CITY OF DALLAS

RE: Appeal of Certificate of Appropriateness:
Hearing – October 3, 2022
4512-4518 Sycamore St., Case No. CA212-354(RD)

**4512-4518 SYCAMORE
STREET
APPEAL
CA212-354(RD)**

**City Plan Commission
Hearing
01/05/2023**

Photo #5

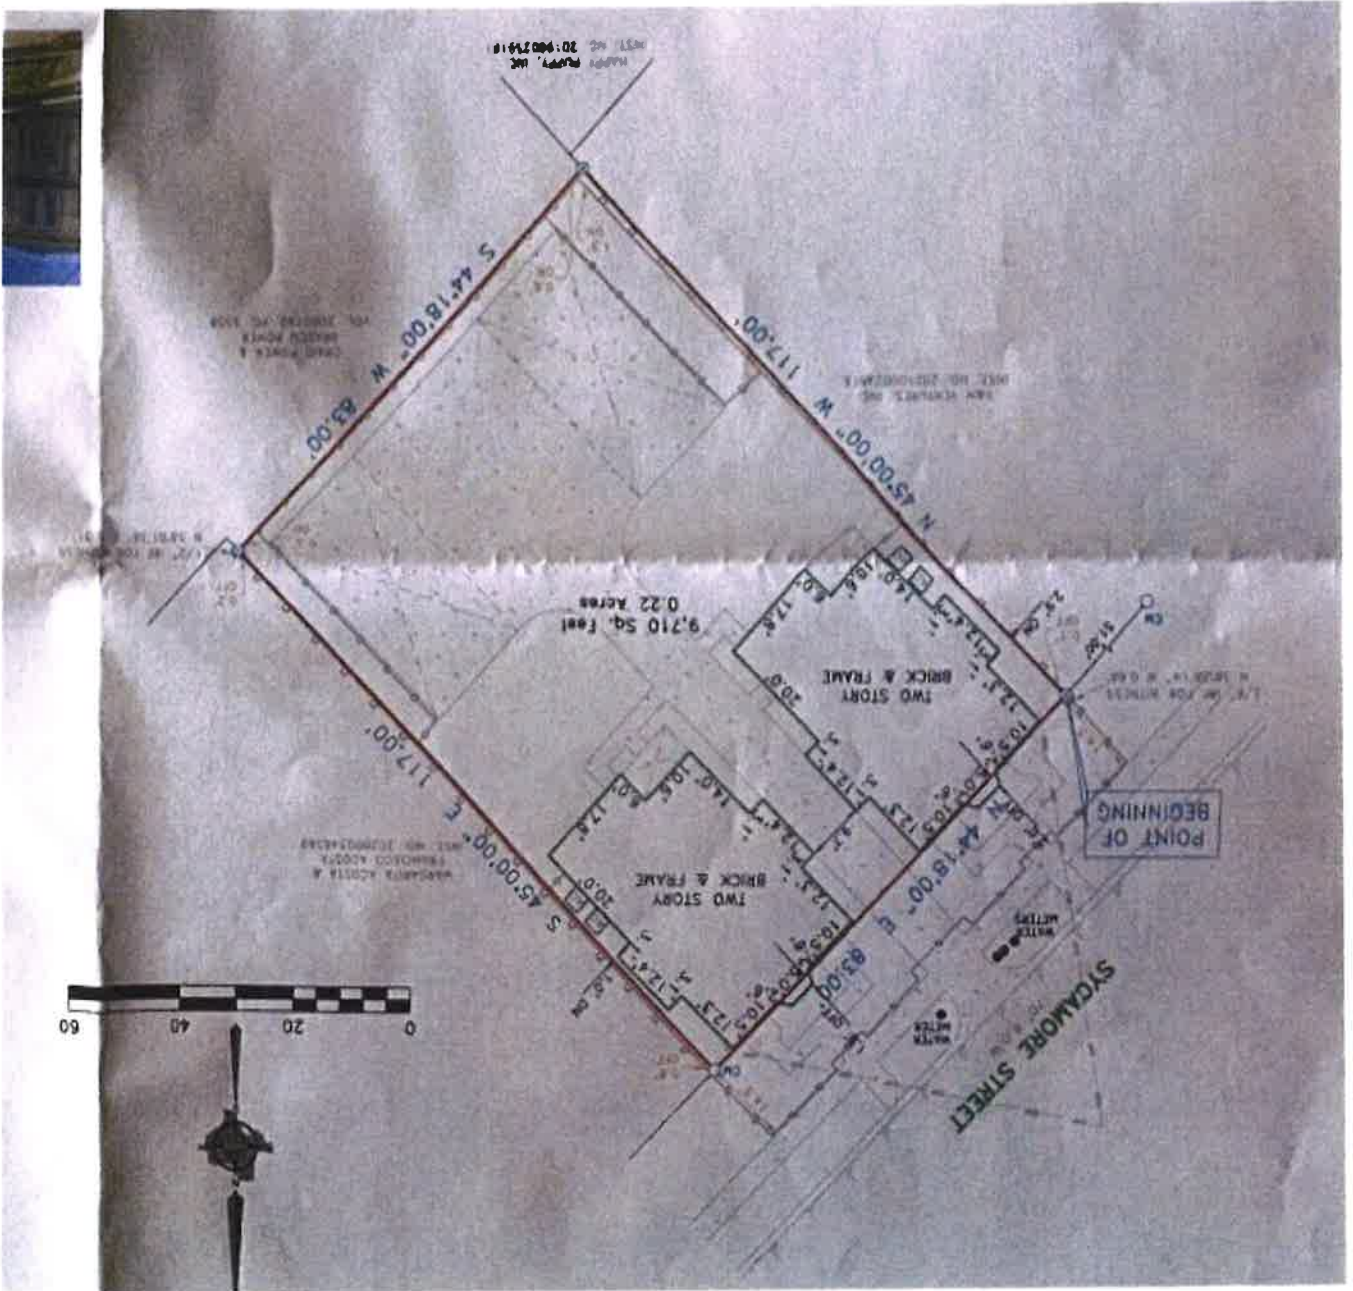
Photos #1 & #2: These photos are of carport #1 showing the bending that has occurred. You can see in the highlighted circles where the bending and bowing has happened over time. We would like to replace the roof only so they are safe for cars to park under.

Photos #3 & #4: These photos are of carport #2 and show the bending that has taken place over time to this roof. You can see in the highlighted circles where the bending and bowing has taken place. We would also like to replace this roof to allow for safe parking of vehicles.

Photo #5: An example of what the new aluminum carport roofs will look like. They have a clean and simple look similar to the ones we would like to replace, while also looking updated.

- 4) That the request for a Certificate of Appropriateness to replace roofs on two existing carport structures, in rear yard be approved in accordance with specifications dated 9/1/22. The proposed work is consistent with City Code 51A-4.501(g)(6)(C)(ii) for non-contributing structures, and the Secretary of the Interior's Standards.

- 4) That the request for a Certificate of Appropriateness to replace roofs on two existing carport structures, in rear yard be **approved** in accordance with specifications dated 9/1/22. The proposed work is consistent with City Code 51A-4.501(g)(6)(C)(ii) for non-contributing structures, and the Secretary of the Interior's Standards.

SASH - EXPLODED VIEW

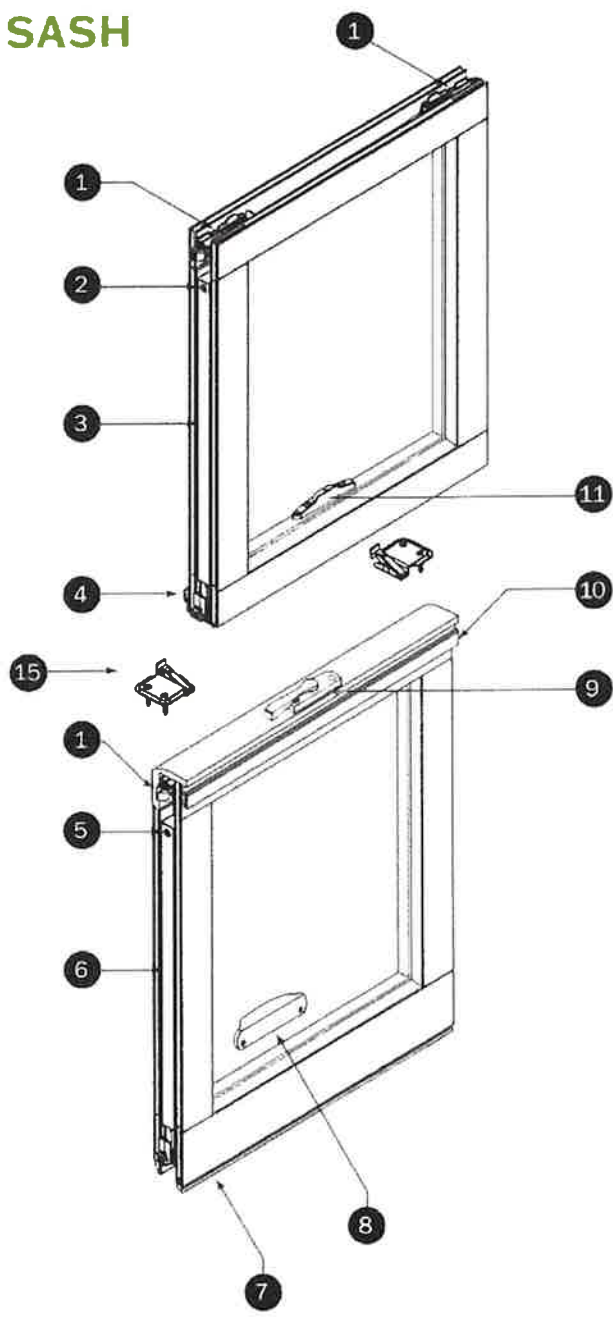
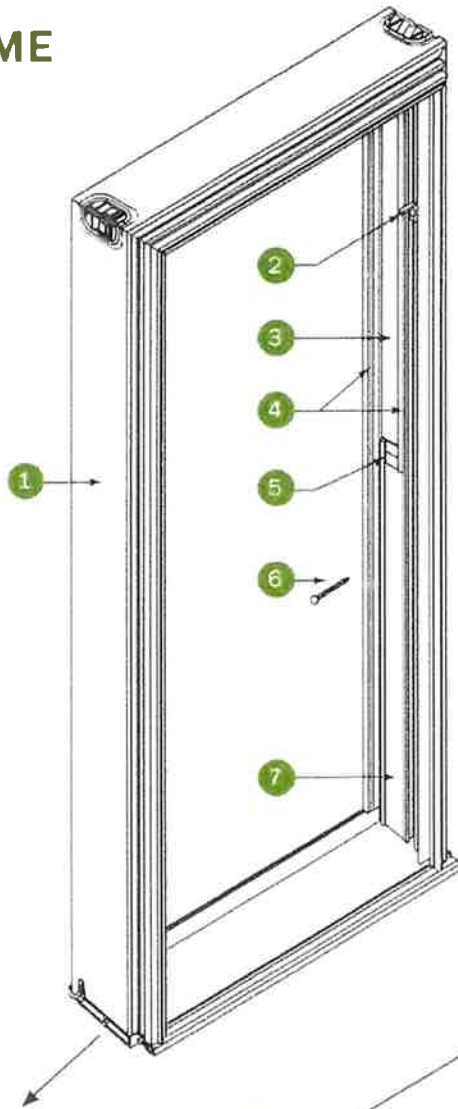
2 don't see on the detail that's provided
3 that -- it looks like the meeting sash
4 is the same dimension as the side rail
5 sashes and the top rail sashes. I don't
6 see a difference between your meeting
7 rail sash. That's a very prominent
8 feature on historical windows, interior
9 windows, and I don't see that.

14 COMMISSIONER CUMMINGS: No, I'm
15 talking about the bottom sash. There's
16 also indications of differences on the
17 thickness of the meeting sash, but let's
18 just talk about the bottom sash. What's
19 your dimension on your bottom sash? And
20 I also don't see a sill detail that was
21 called out, and you had three choices on
22 the windowsills.

11 COMMISSIONER CUMMINGS: Correct.
12 It doesn't seem like there's a
13 difference between the bottom sash
14 dimension and the side dimension.

5. That the request for a Certificate of Appropriateness to replace wood windows with wood composite windows be **denied**. Wood composition windows are not wood, and these windows would have an adverse effect on the historic district. Work is not consistent with 51A-4.501(g)(6)(c)(ii) for non-contributing structures. Proposed work is not compatible with the historic district.
